Staff Report

Re: PLNHLC2021-00900 - Minor Alteration

PROPERTY ADDRESS: 563 East 800 South
PARCEL ID: 16-07-231-036-0000
HISTORIC DISTRICT: Central City Local District

Ted Konold, representing the property owner, is requesting a certificate of appropriateness from the Historic Landmark Commission to construct a rear addition to the house. As part of this request, the applicant is asking for a waiver of the interior side-yard setback.

SOUTH ELEVATION

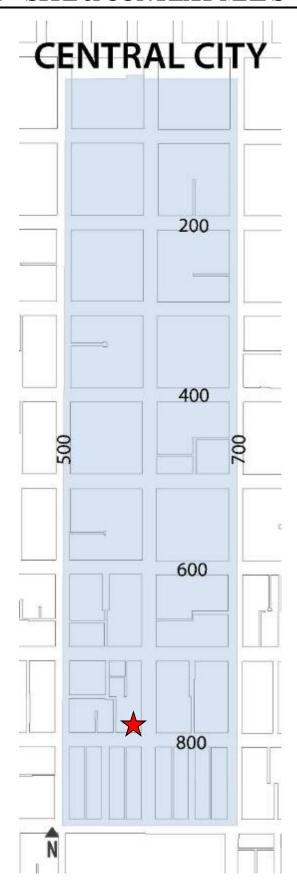
The roof form and height of the house are primary character-defining elements of the structure. While the proposed addition maintains the existing roof's slope, it sits seven feet above the house. On paper, the proposed additional height of the addition makes it appear much larger than the existing house. However, elevation drawings tend to flatten how

the final product would look from the ground. While the proposed addition does sit on top of the existing building, it is also set back from the front of the house. The proposed addition would have a much smaller impact on the house's character when viewed from the street than on the plans. The applicant provided a drawing of what they expect the roofline to look like from the street. While the impact of the new roofline is softened by the fact that it sits behind the front of the building, it's clear that there would still be an impact. The taller chimney (as required by building code) is also very visible from the street.

The commission should note that 800 South is quite wide, and the addition's impact on the view from the opposite side of the street will likely be greater than from in front of the house. Overall, the addition's height would impact the district's character.

Examples of rear additions near subject property (provided by applicant)

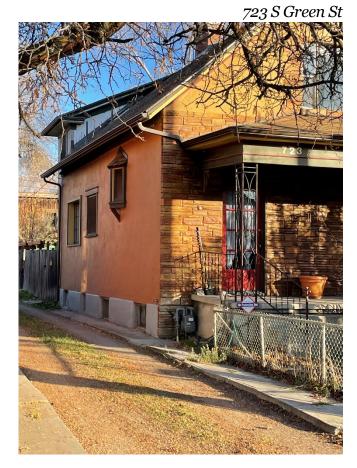
The applicant has told staff that the scope and design of the proposed addition are based on existing rear additions in the neighborhood. They tried to follow what had been done before in hopes that a precedent had already been set. In an attempt to make this case, the applicant has provided some examples (which can be found in Attachment E). While staff acknowledges that rear additions similar to the one proposed are present throughout the neighborhood, it will ultimately be up to the commission to determine if the trend in the district should continue with this proposal. Many of the additions were constructed prior to the adoption of the current design guidelines, and some predate the historic district itself. The most obvious example is the house to the immediate east of the subject property. That addition was constructed in 1997 (the local historic district was established in 1991 and the current design guidelines were adopted in 1999). In the analysis of the relevant standards in Attachment F, Staff has noted the examples provided by the applicant.

563 E 800 S Close View Before

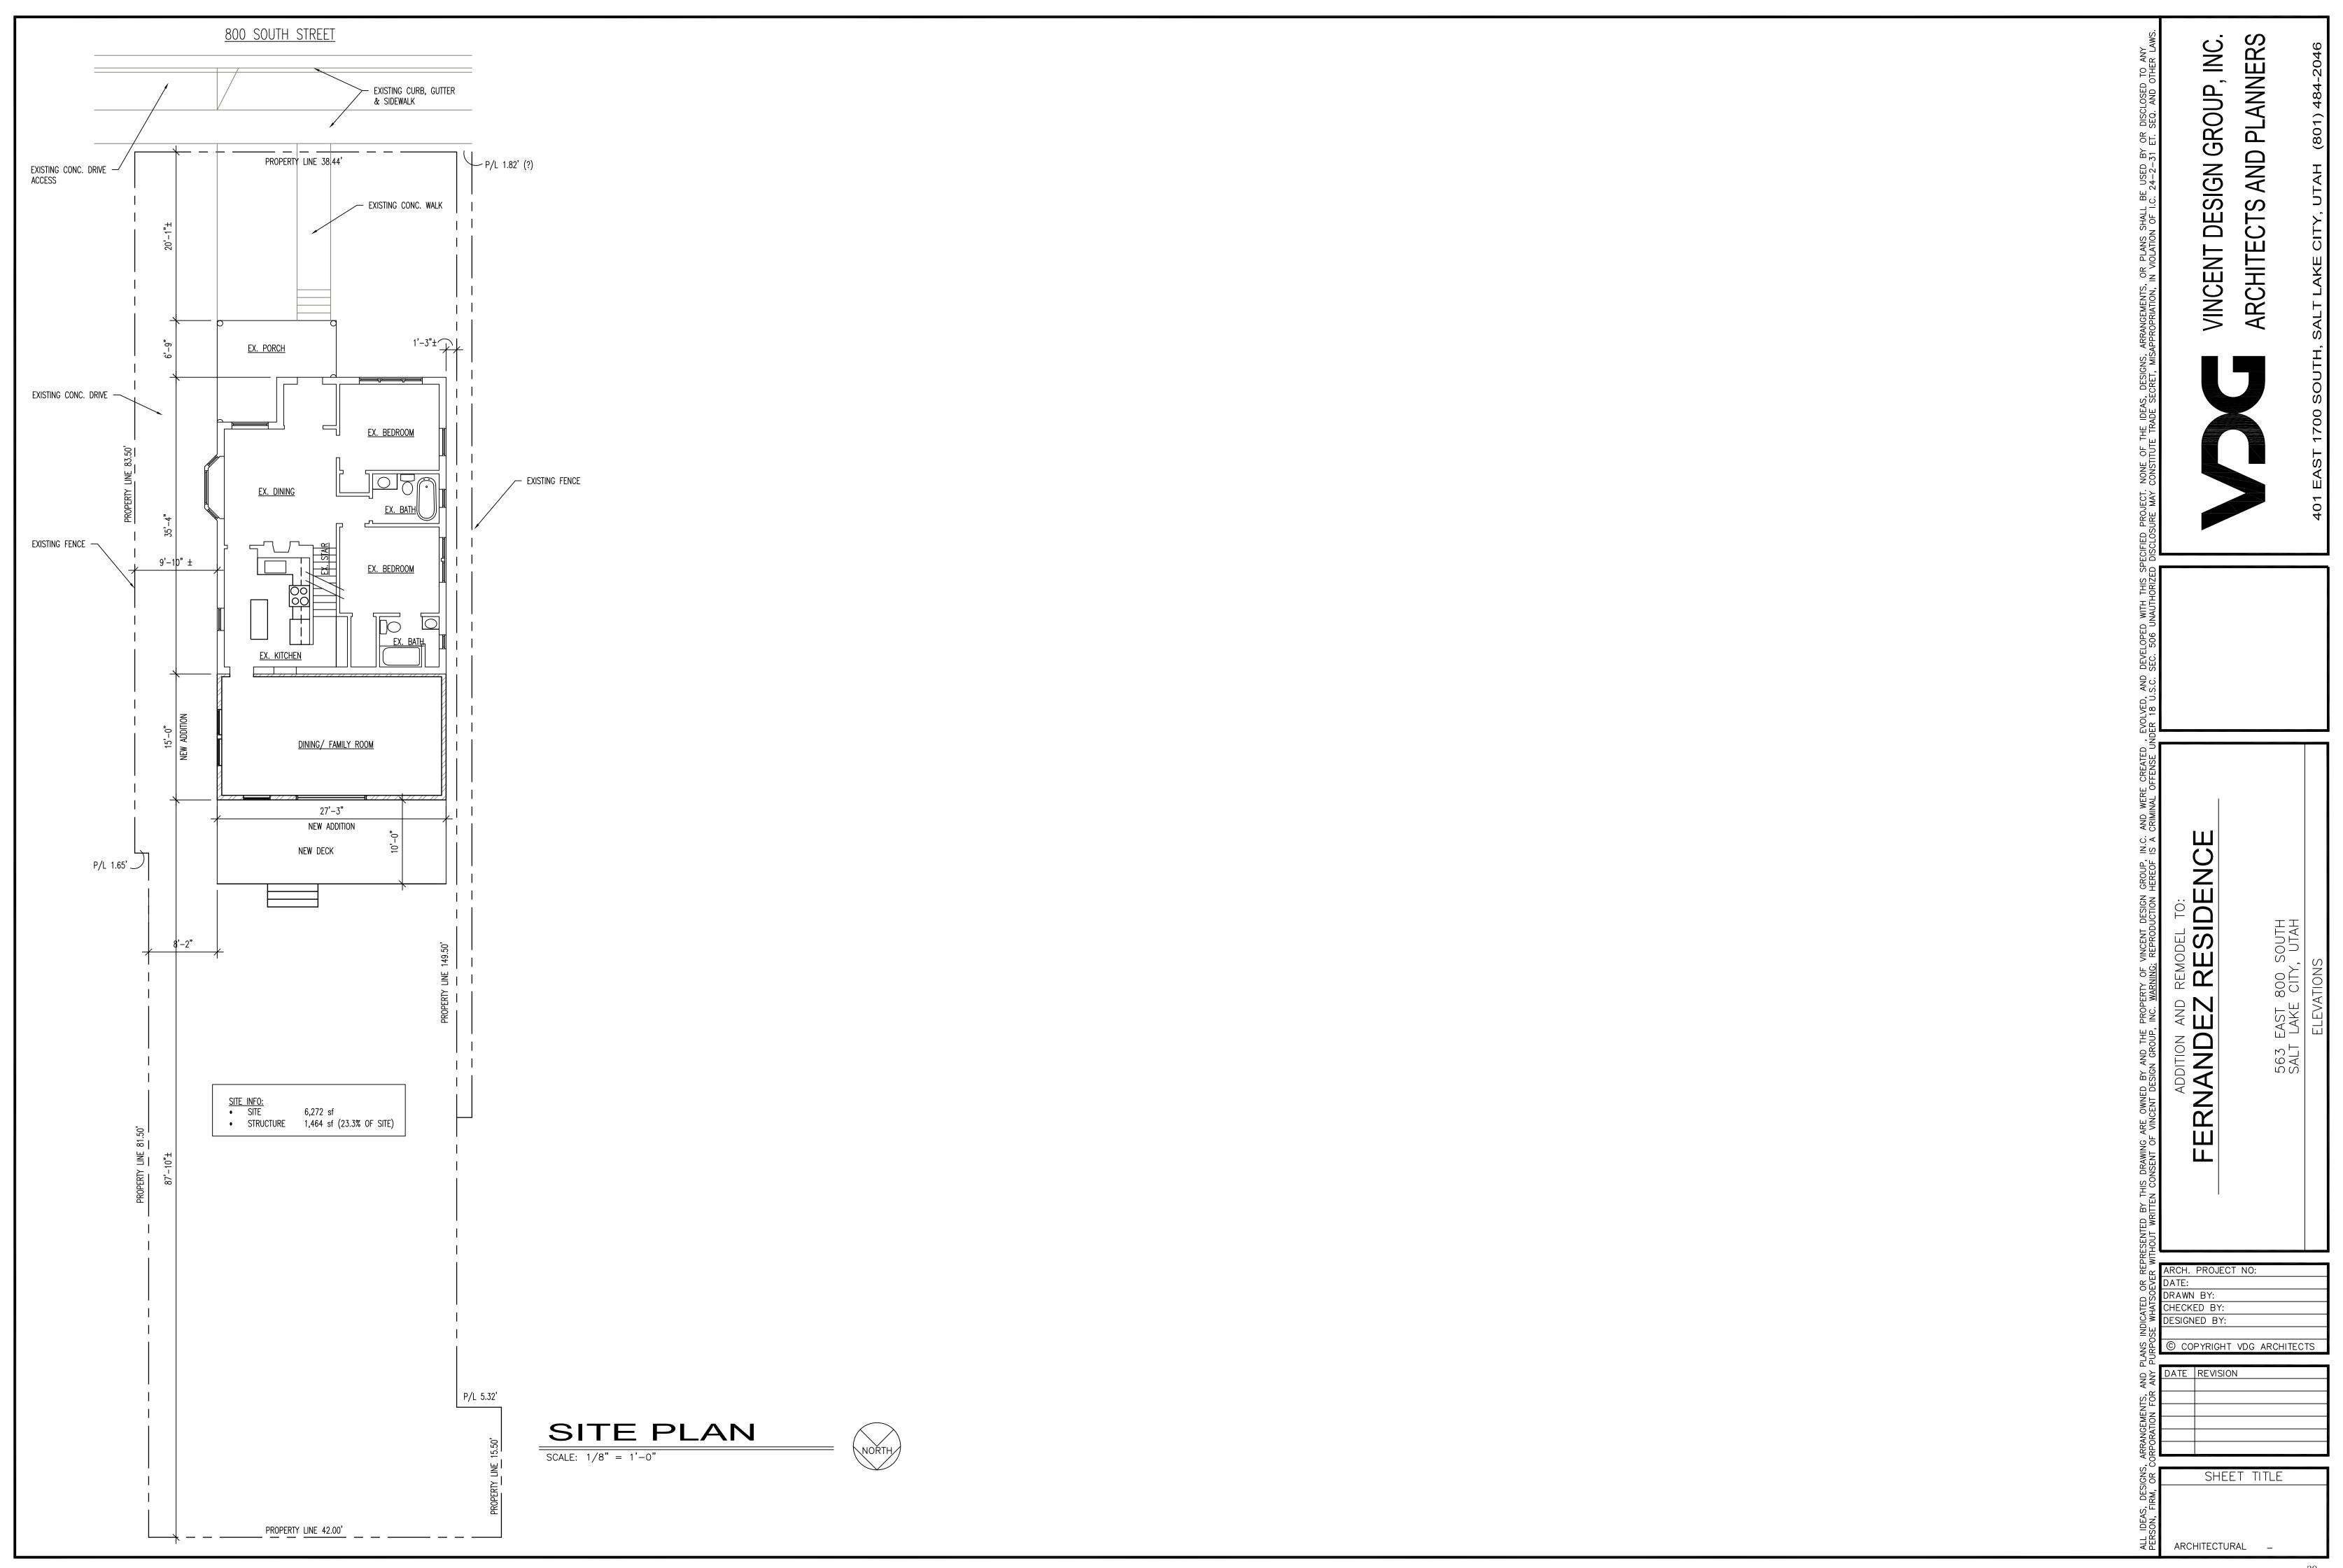
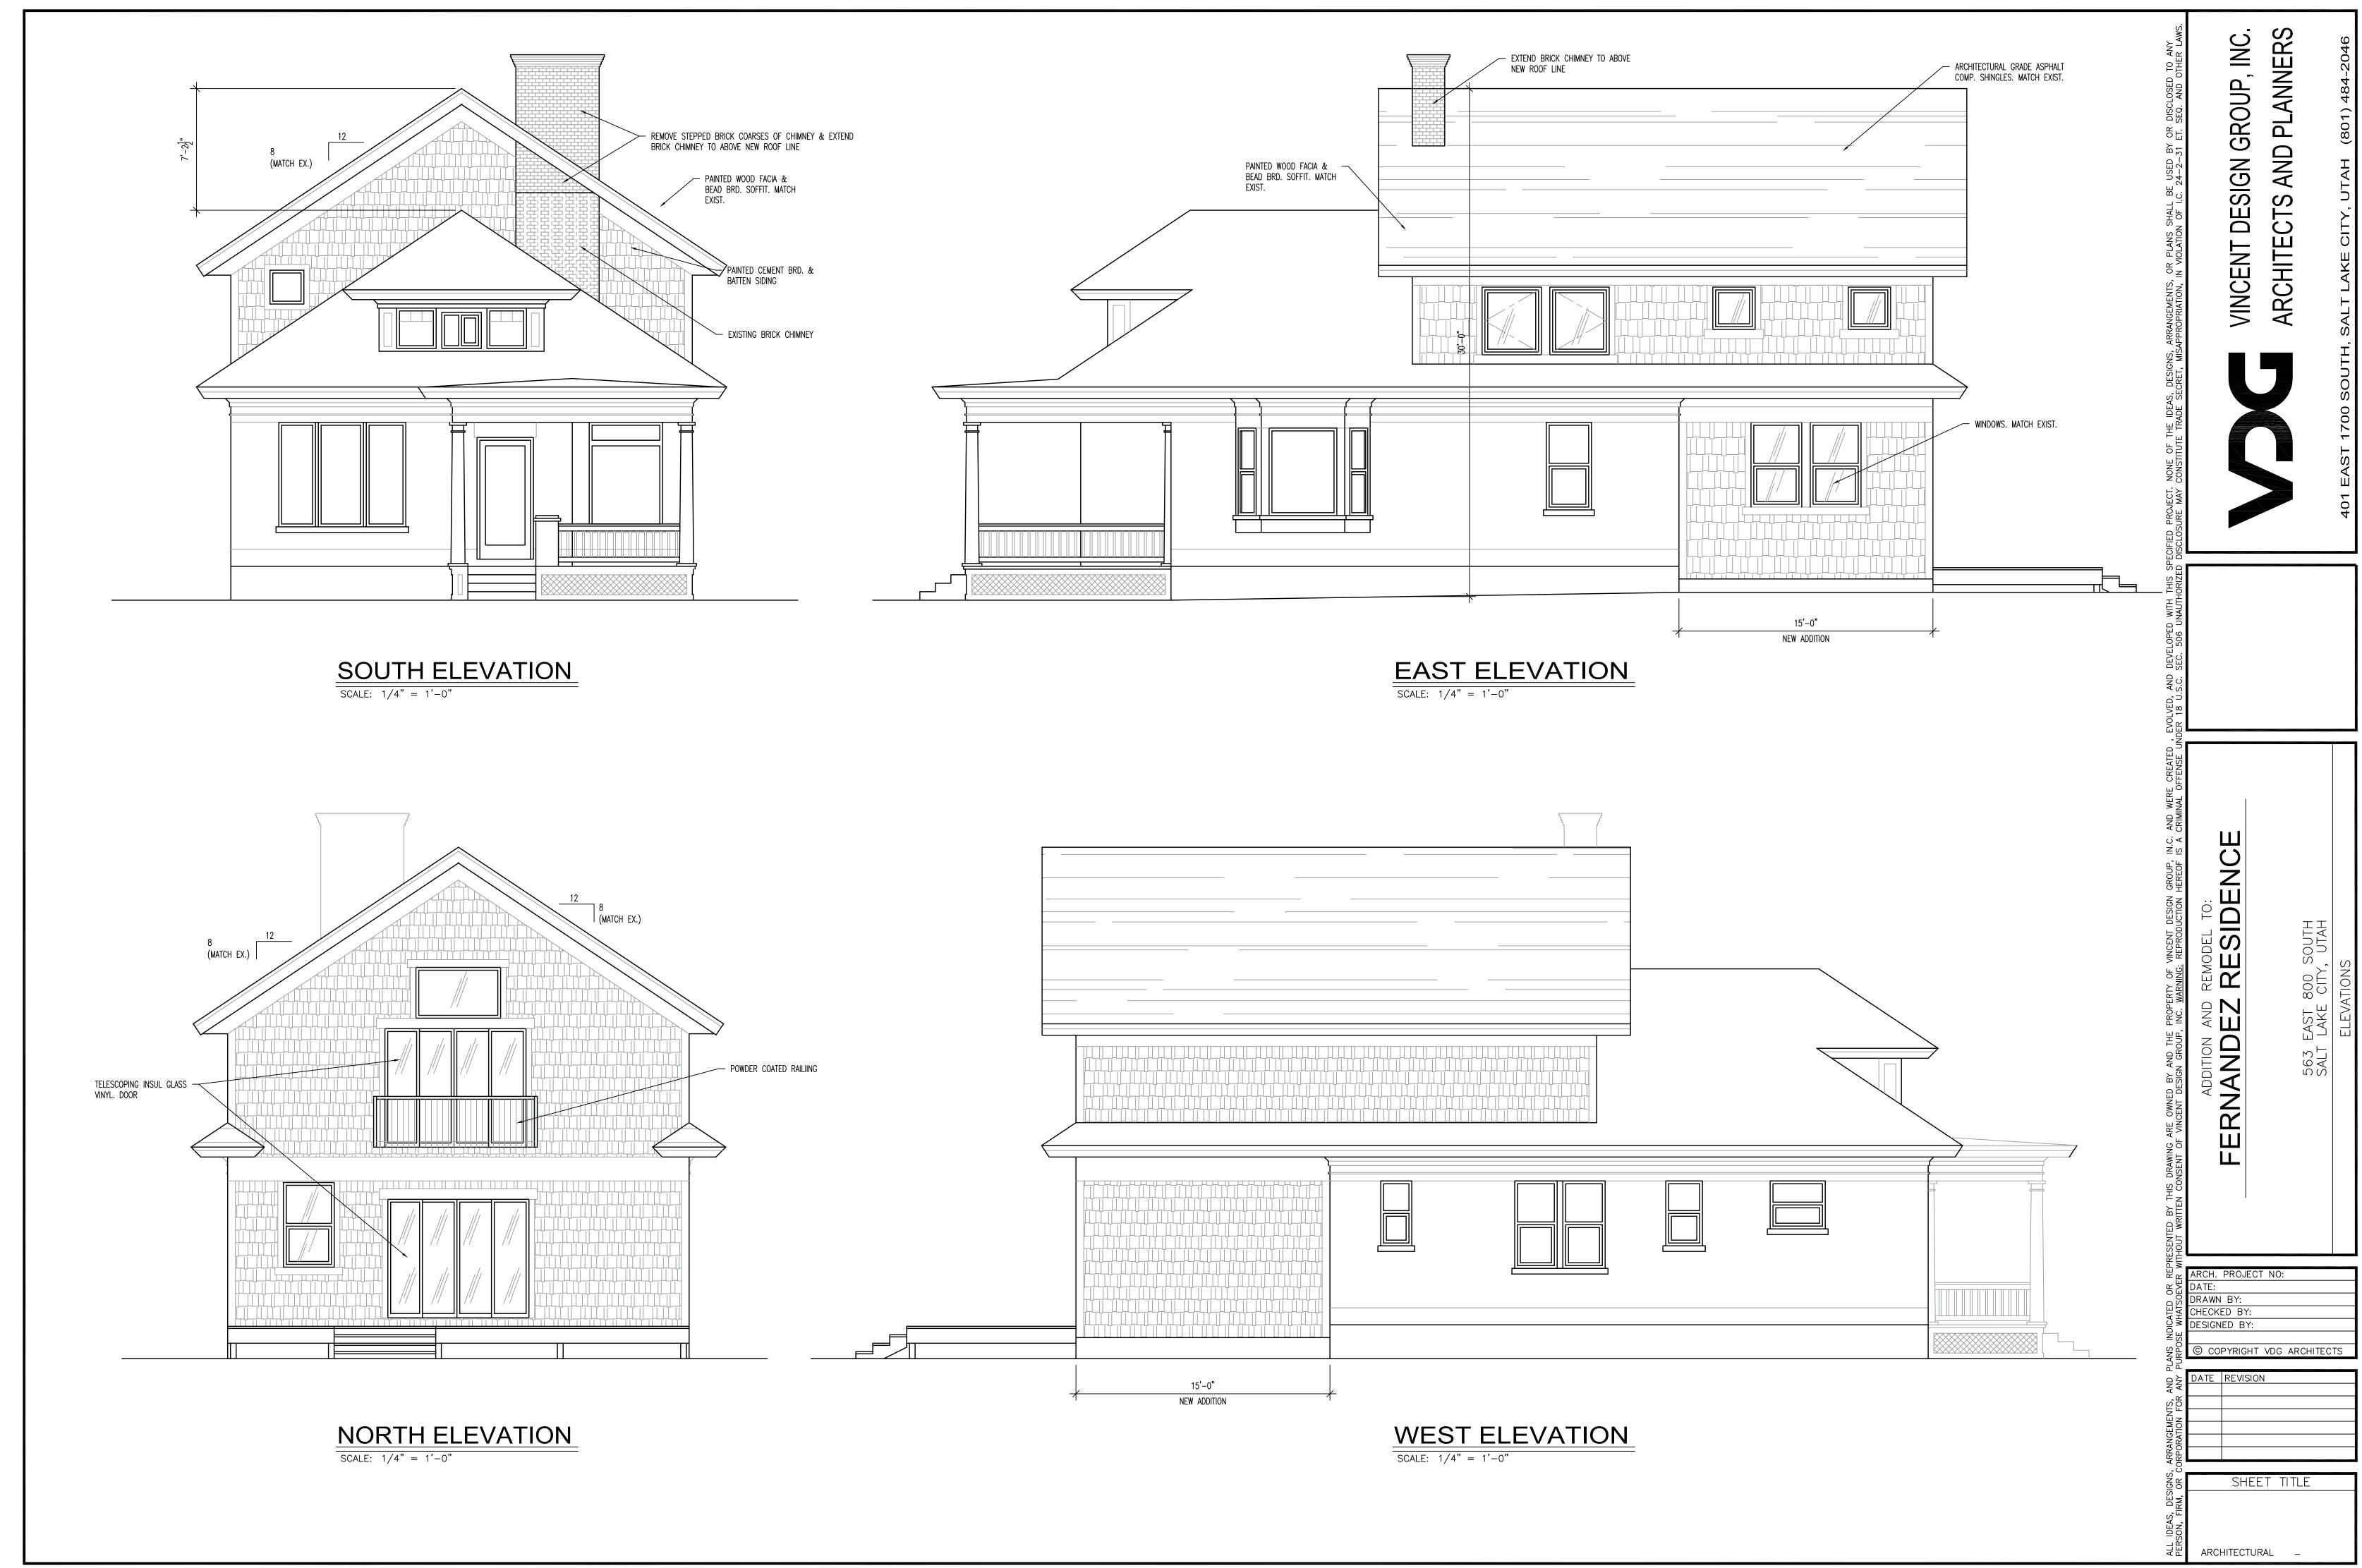
The proposed property change will have minimal front appearance impact. It will maintain the characteristics of like buildings in the district that also have been modified.

The Changes will not affect any historical materials on the building. Only a portion of the back part of the roofing structure will be removed. A permit was given recently to re-roof the home. Same materials will be used.
